Sixth floor level

DA

Proposed

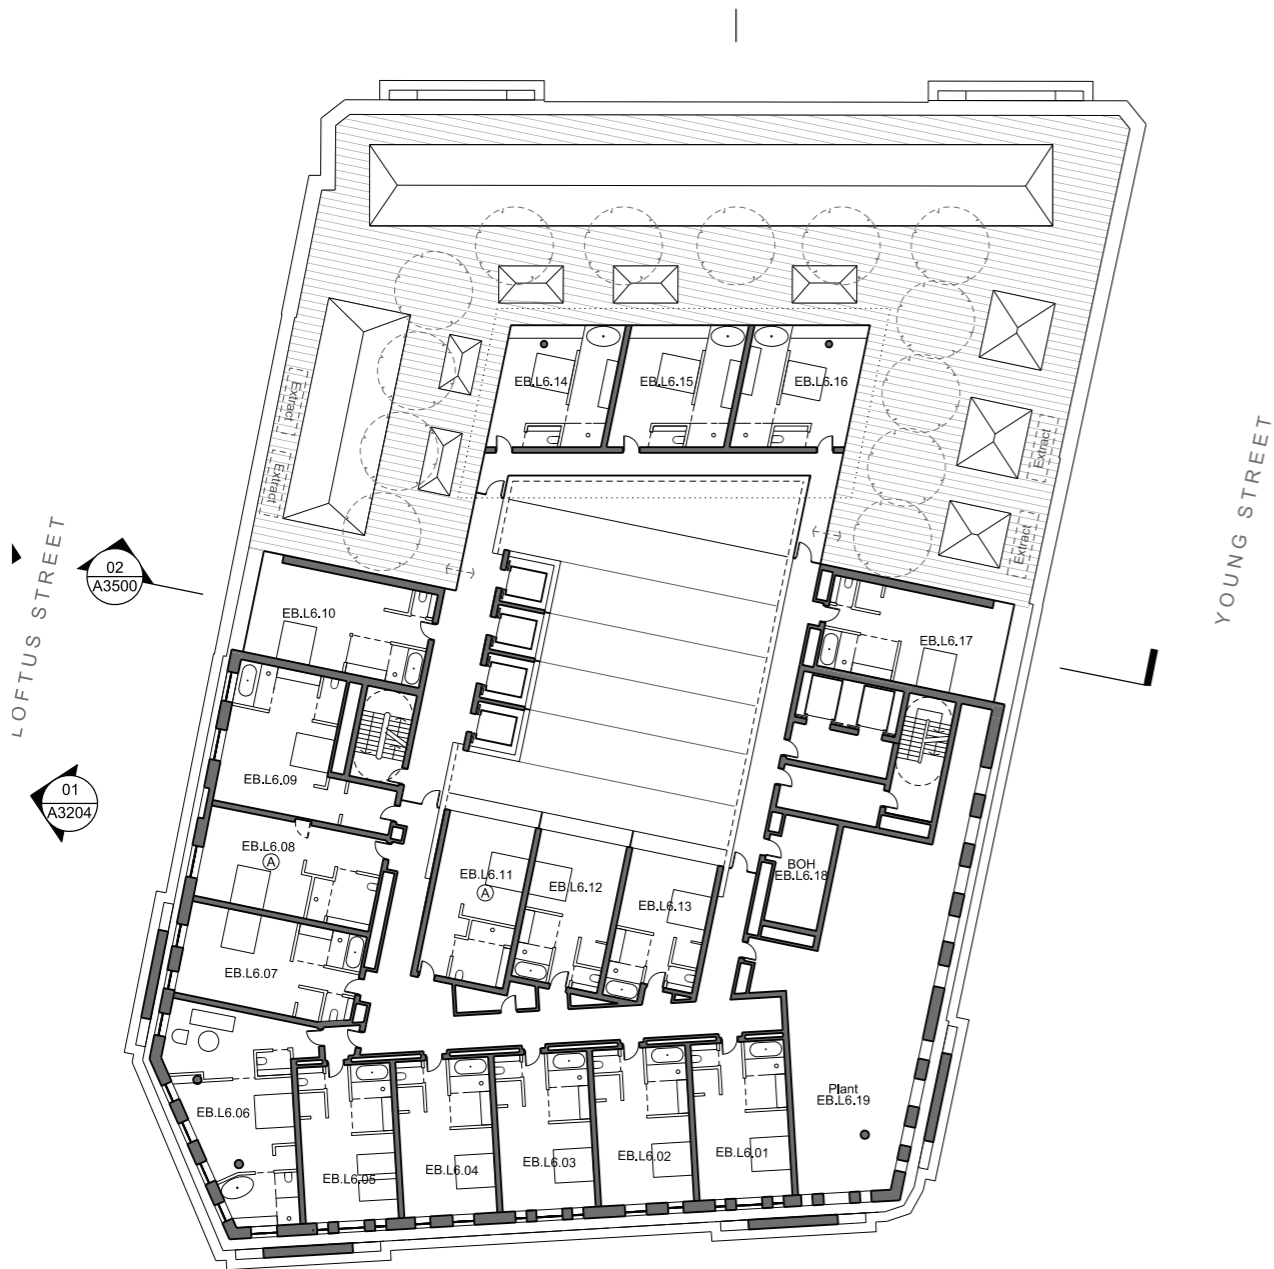
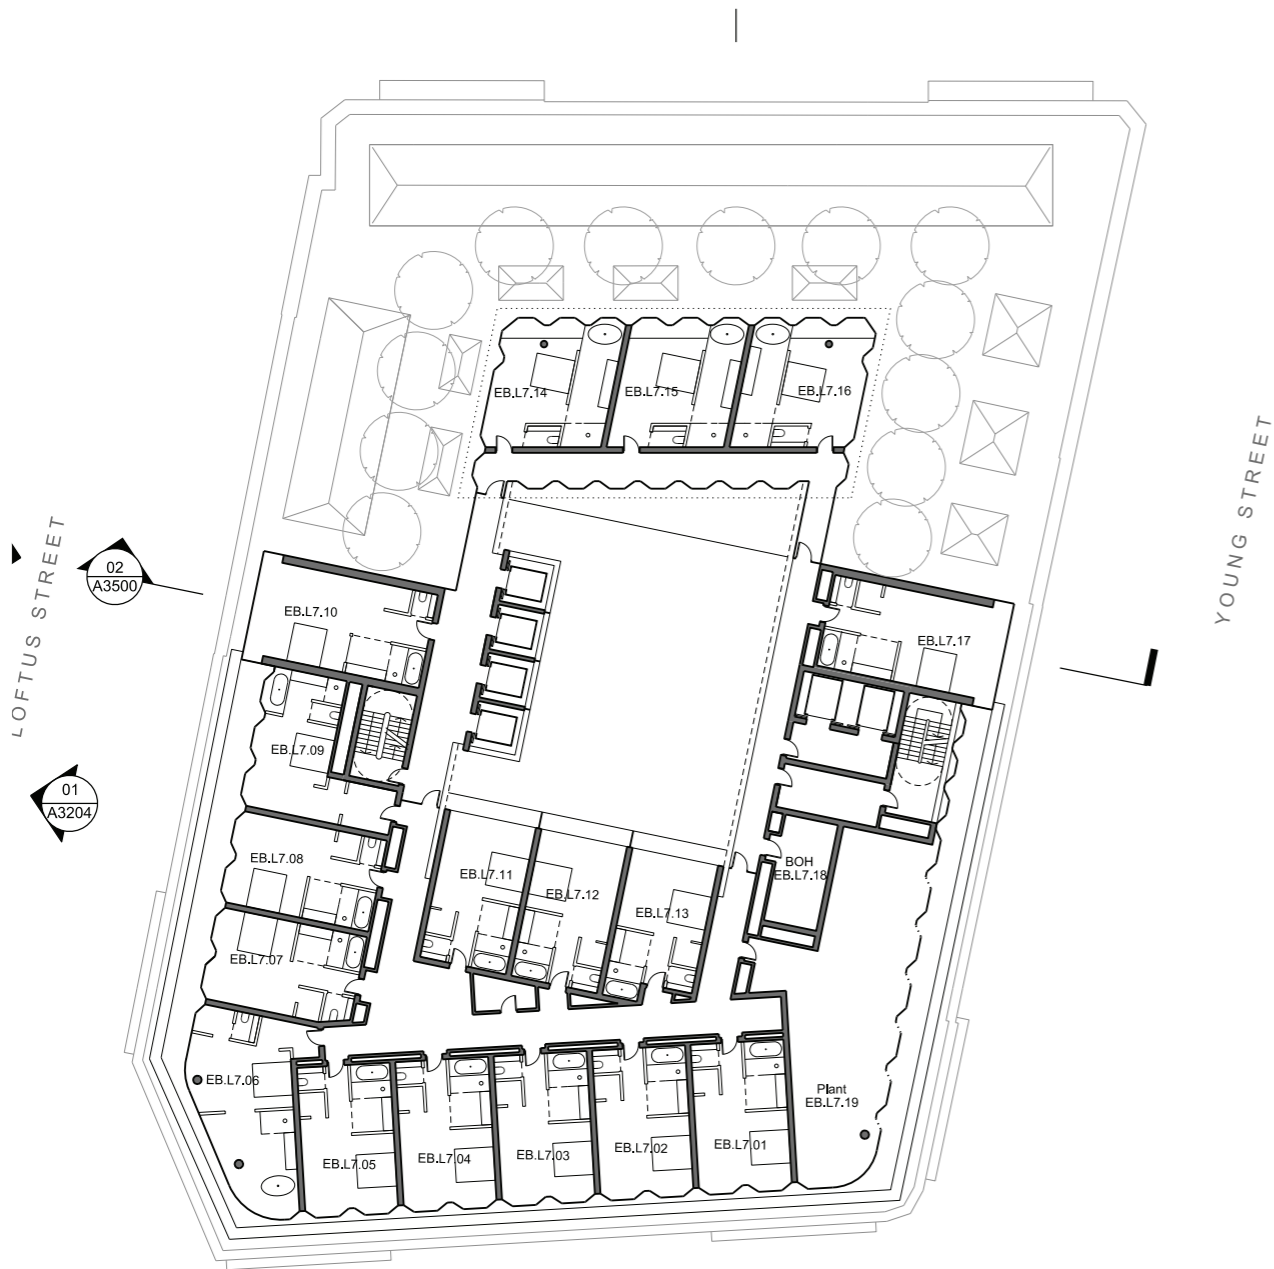
1. Facade extended south towards courtyard. Additional guestroom added
2. BoH lifts and housekeeping relocated north
3. Cooling towers moved to level 9 and replaced with 3 additional guestrooms
4. Winter gardens removed and secondary glazing installed
5. Additional key per zone

Seventh/eighth floor level

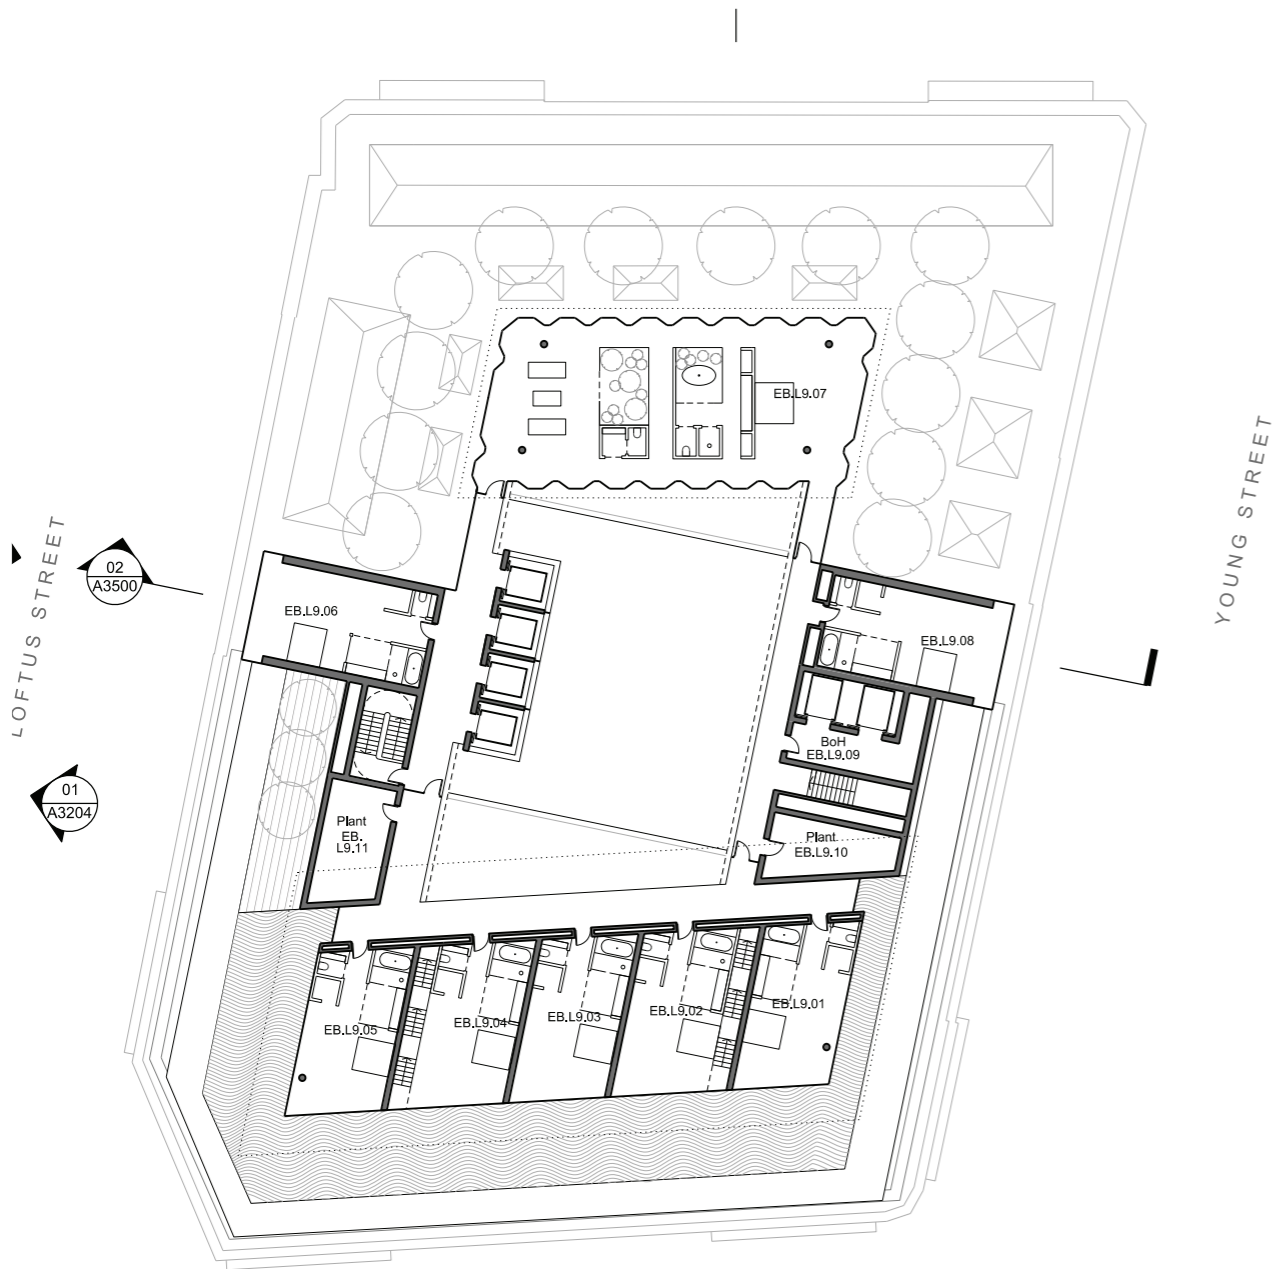
1. Facade extended south towards courtyard. Additional guestroom added
2. BoH lifts and housekeeping relocated north.
3. Cooling towers moved to level 9 and replaced with 3 additional guestrooms
4. Additional key per zone

Ninth floor level

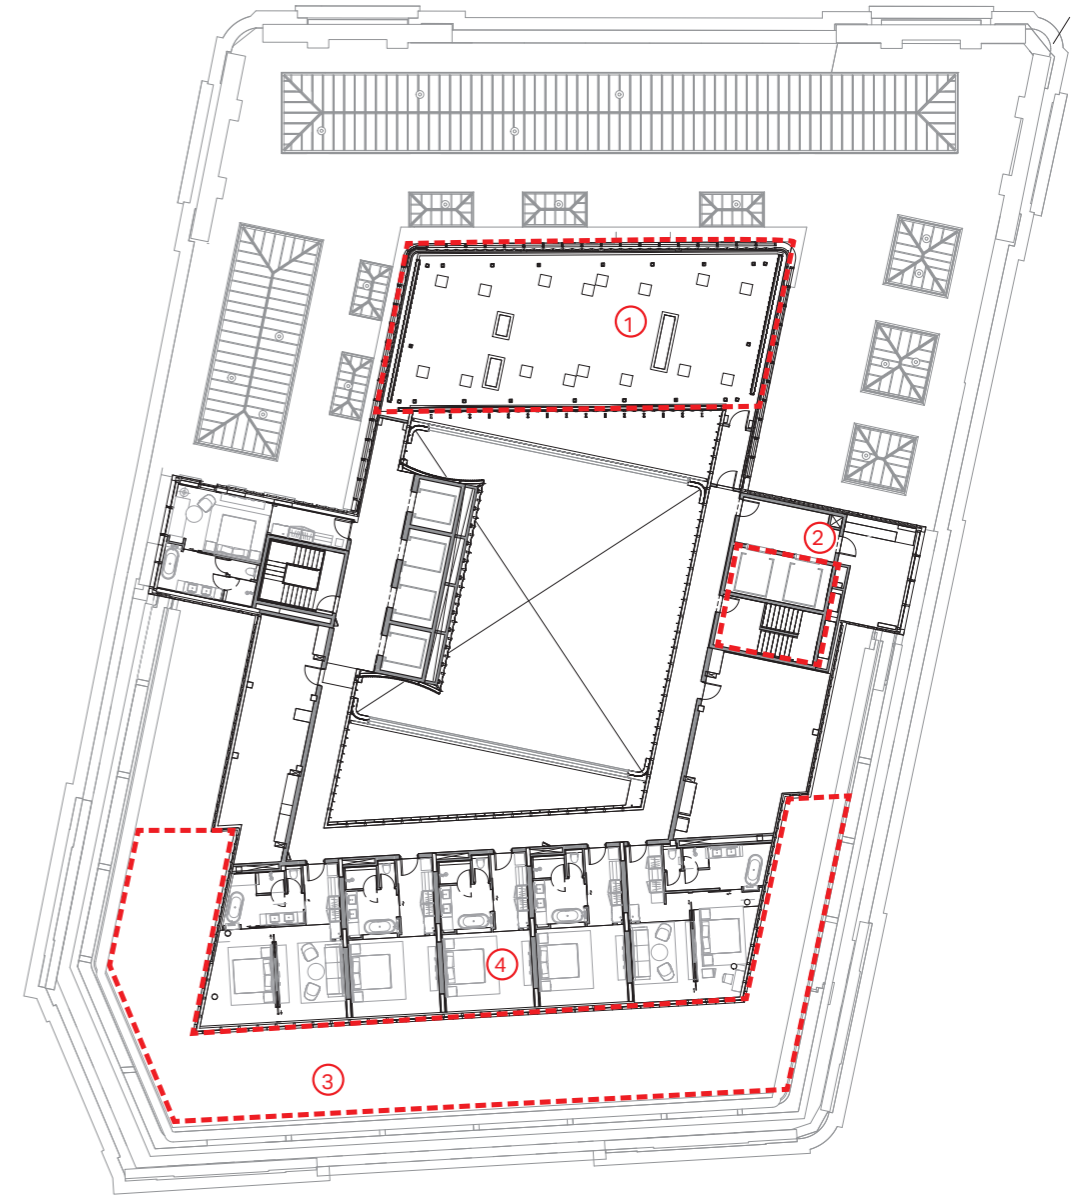
1. Cooling towers relocated to the north. Guestroom removed.
2. BoH lifts and housekeeping relocated north.
3. Water removed and replaced with landscaping
4. Staircases up to terraces removed
